DWG TITLE: UPPER CUTTER ASSY

ENGINEERING CHANGE NOTICE NO. 03724

DWG NO. 646.3300

ENGINEERING CHANGE NOTICE NO.		02196		SHEET 1 OF 2	
DWG NO.	646.3300	REV: N/C	PREPARED BY	S. HUFF	DATE: 01/05/09
DWG TITLE:		UPPER CUTTER ASSY			
APPROVED BY:	ENGR <i>[Signature]</i>	MFG	<i>[Signature]</i>	QC	<i>[Signature]</i>
TRANSACTION CODES (TC): A-ADD C-CREATE R-REVISE D-DELETE		REASON: REMOVED RIVETS IN FAVOR OF ADDITIONAL SCREWS			
		EFF:		NEXT ORDER

SHEET 5 IS:

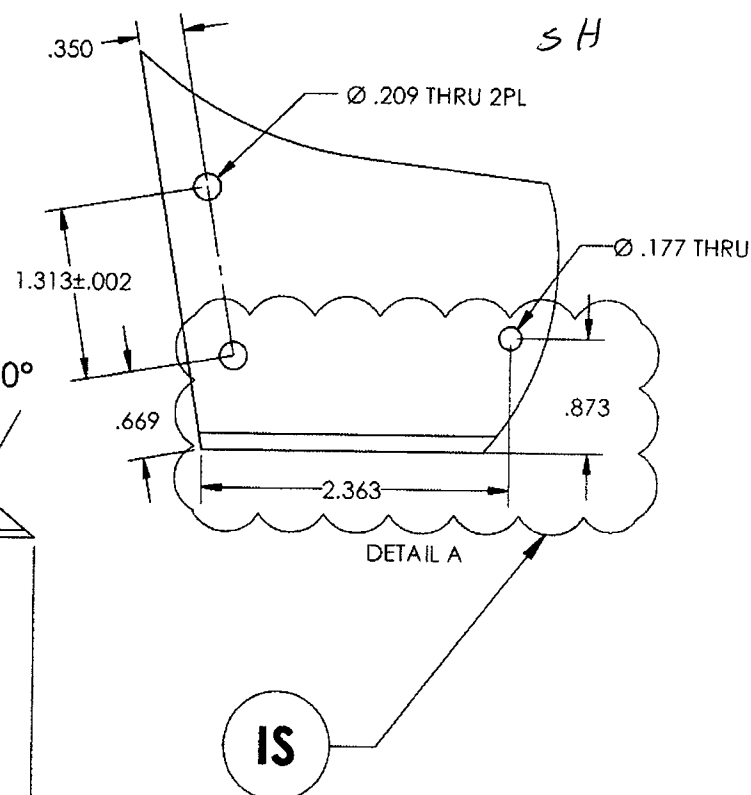
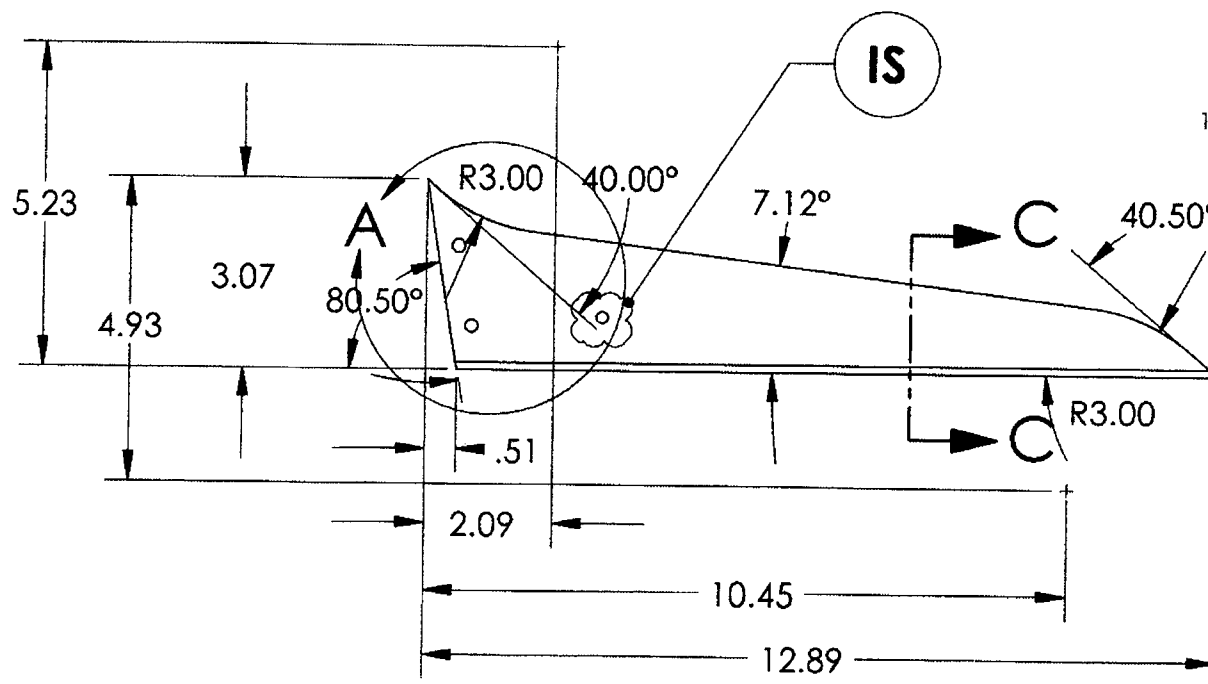
REASON: ADDED HOLE DIMENSION TO 646.3313.

SHEET 4, ZONE B8 IS:

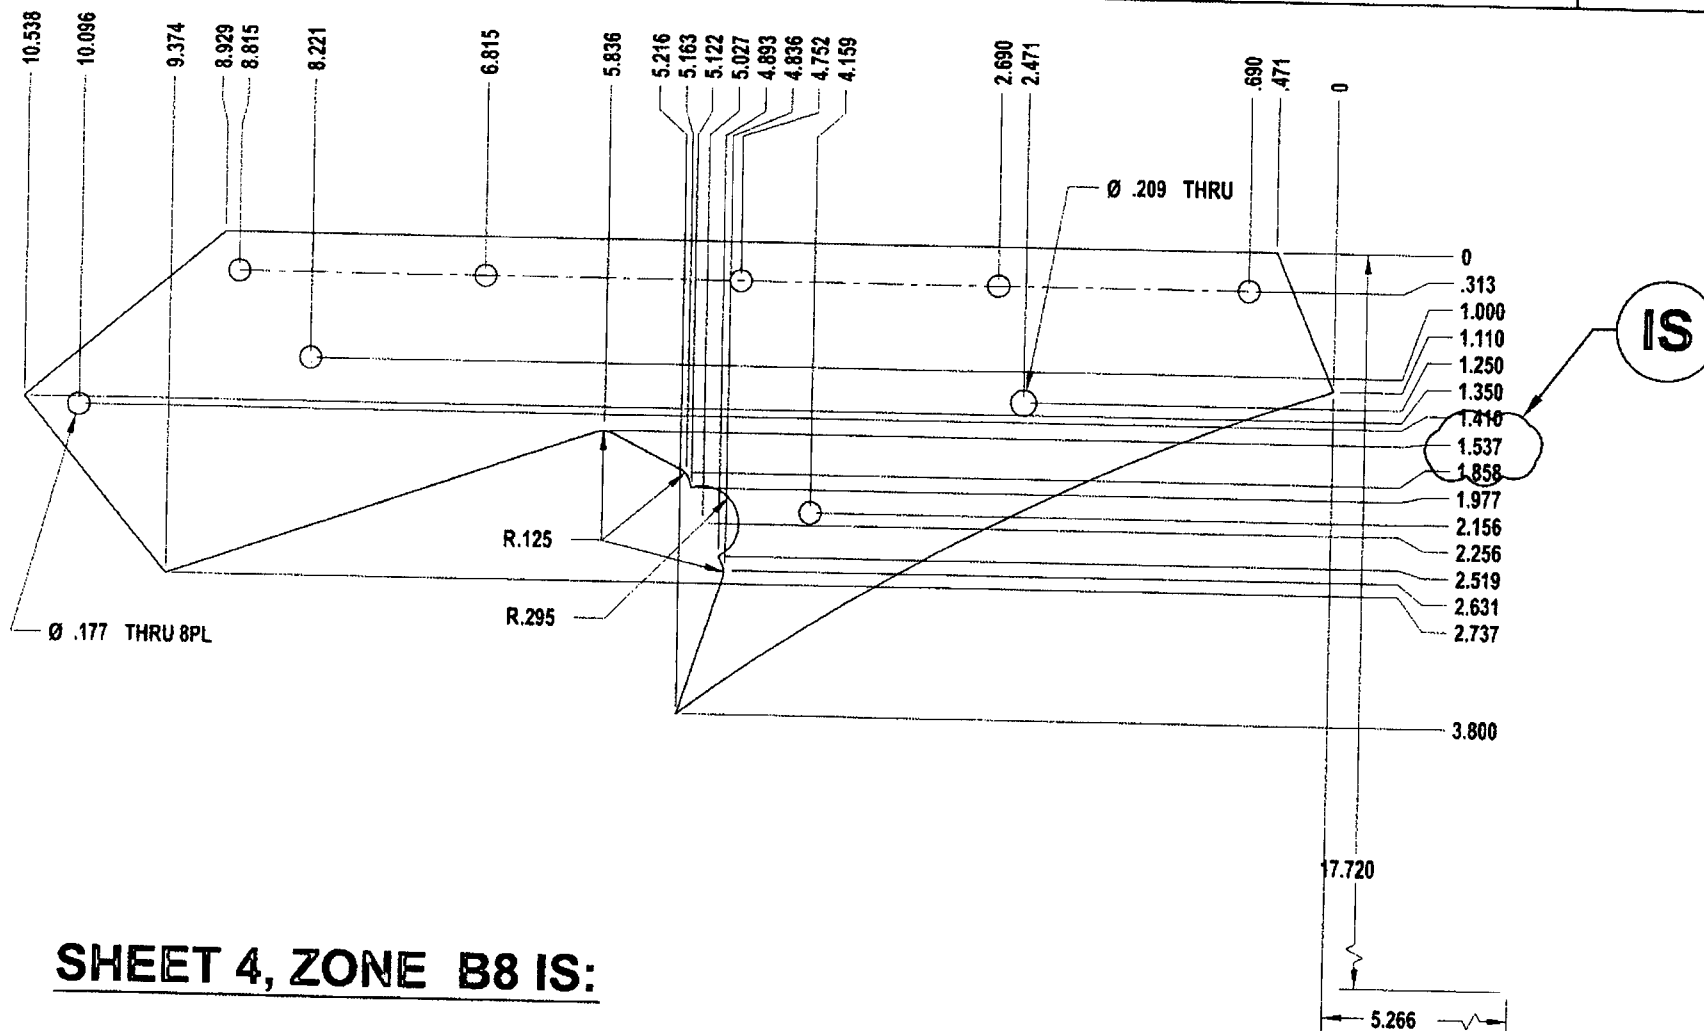
REVISED ORDINATE DIMENSION.
